4. Amended Concept Plan

4.1 Site Access, Street and Public Domain Framework

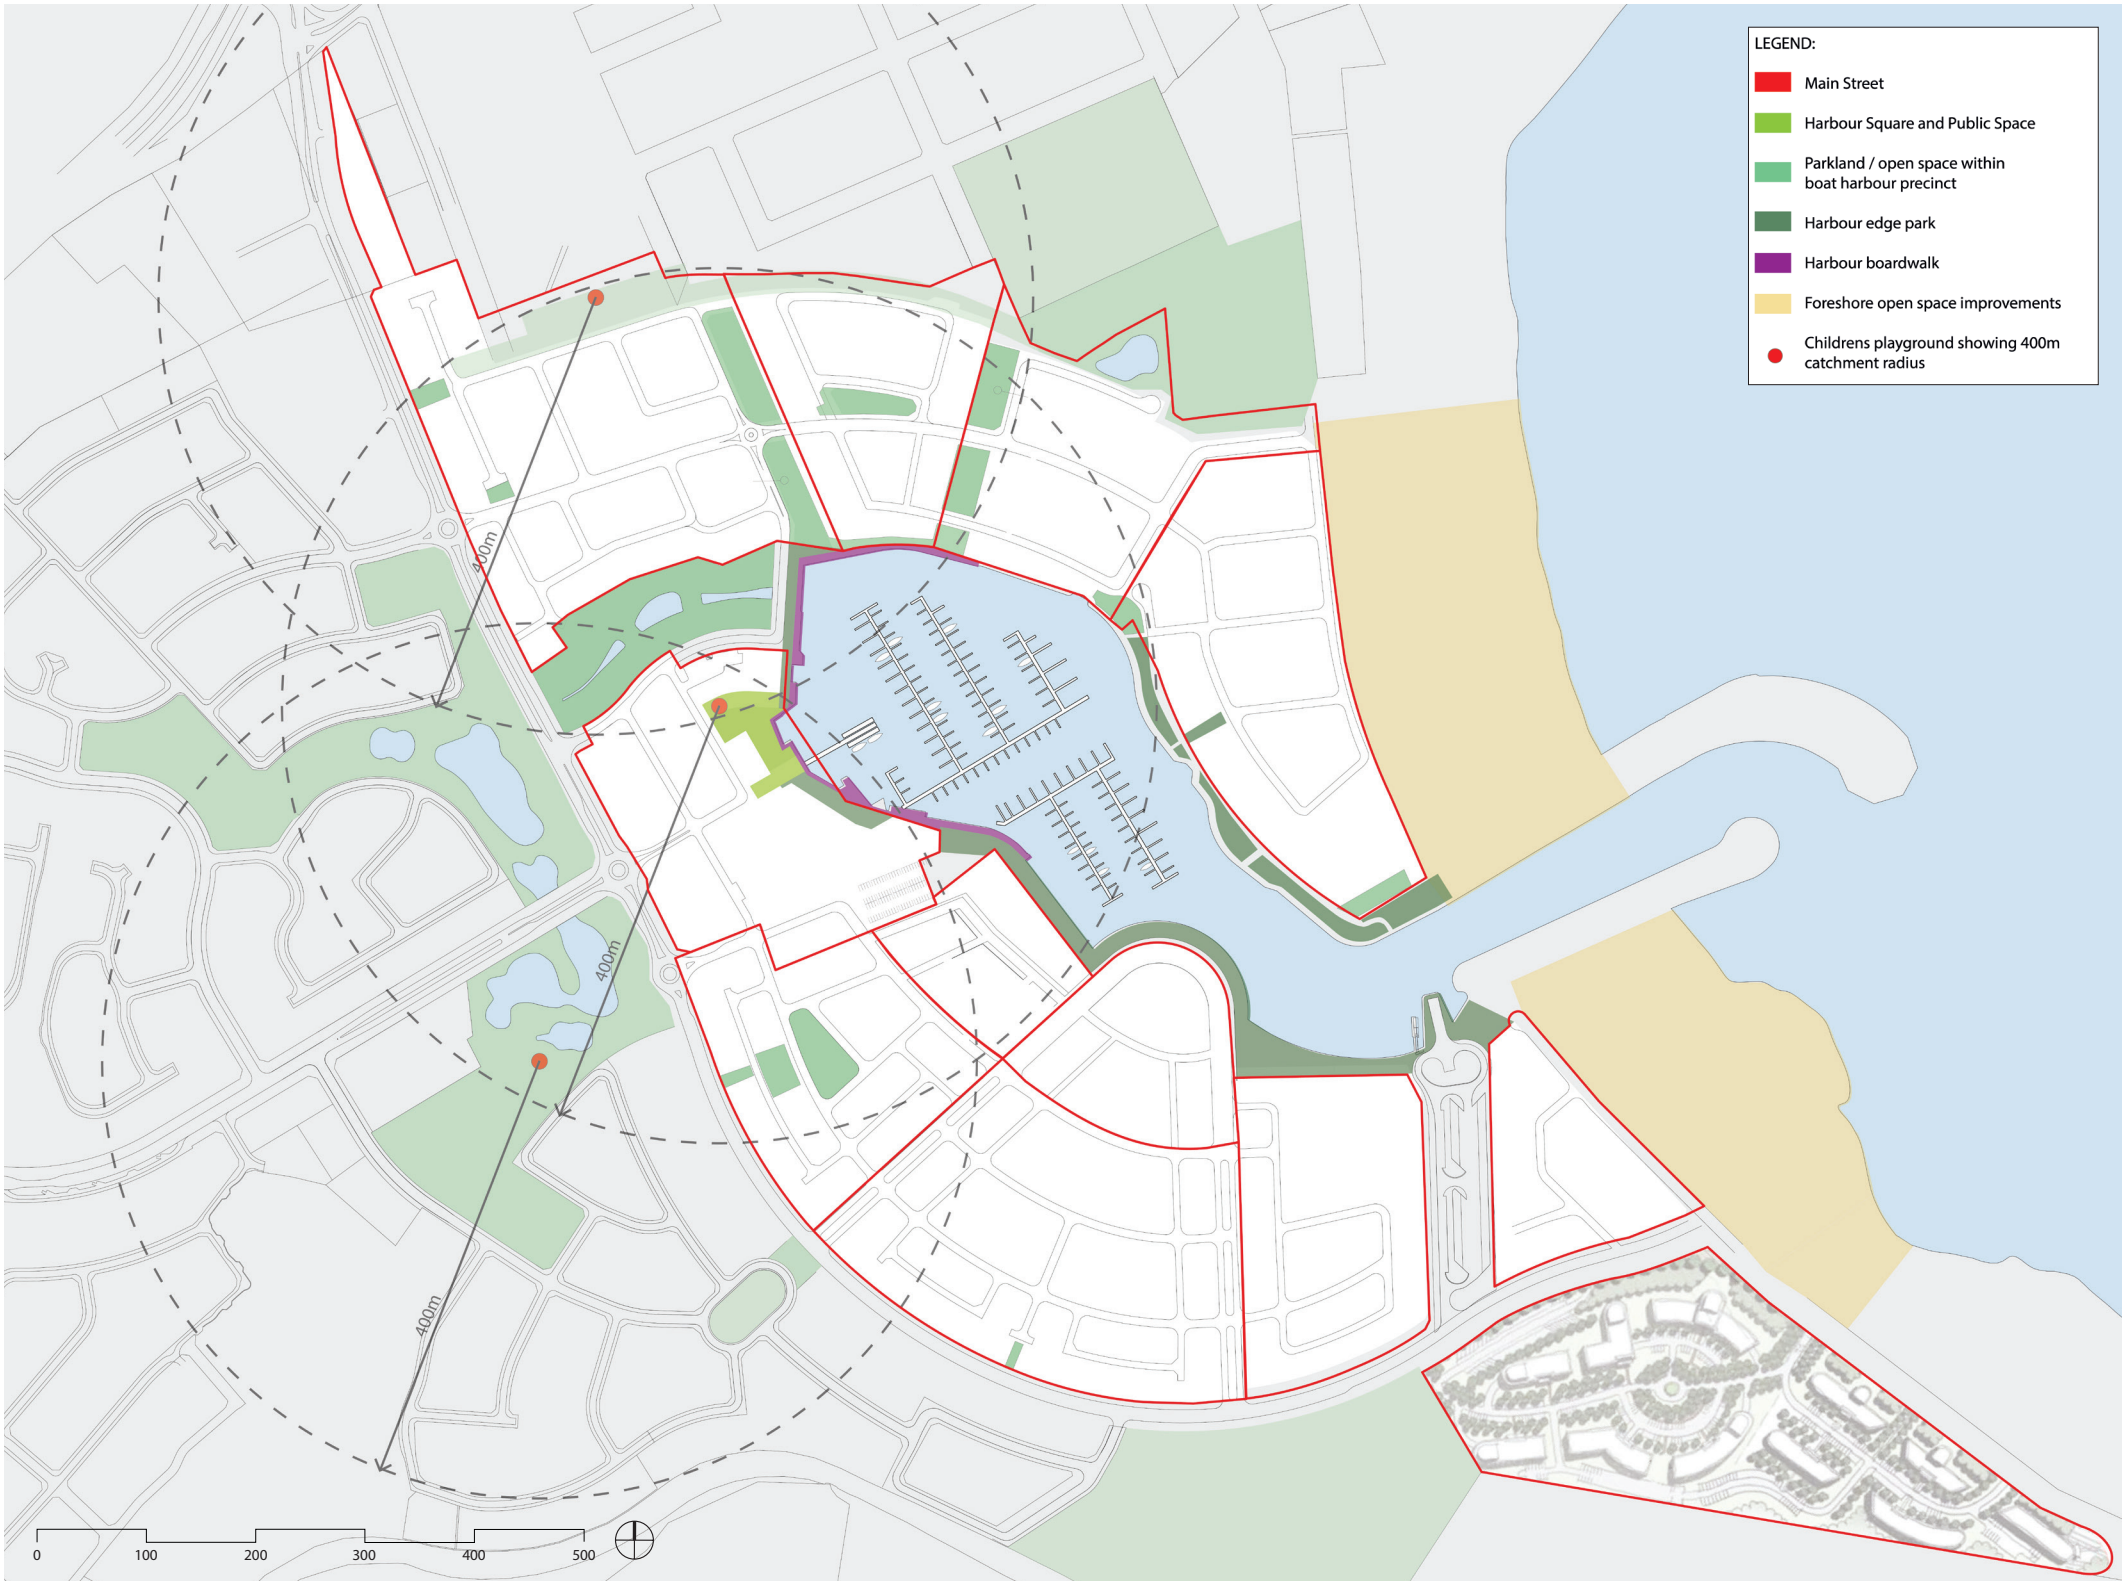
- The addition of low rise apartments on the waterfront with basement parking will reduce on street parking in this area

The street network structure has been amended, with respect to the Approved Concept Plan as follows:

- The addition of streets immediately to the rear of apartment buildings addressing the waterfront which will provide for pedestrian foreshore walkways generally free of vehicle entries
- Rear lanes provided to terraces, avoiding street frontages dominated by driveways, allowing for more efficient on street parking for visitors

- Avenues (type 1) have been maintained, namely Harbour Boulevard
- Connecting Streets (type 3) have been maintained
- Visual Corridors (type 2) have been amended as follows:
 - Precinct A – The Visual Corridor has been moved east so that a strong visual corridor extends from Harbour Boulevard to the Boat Harbour
 - Precinct C- Precinct C has been reconfigured to include a new neighbourhood park. Two strong visual corridors are achieved as per the approved concept plan.
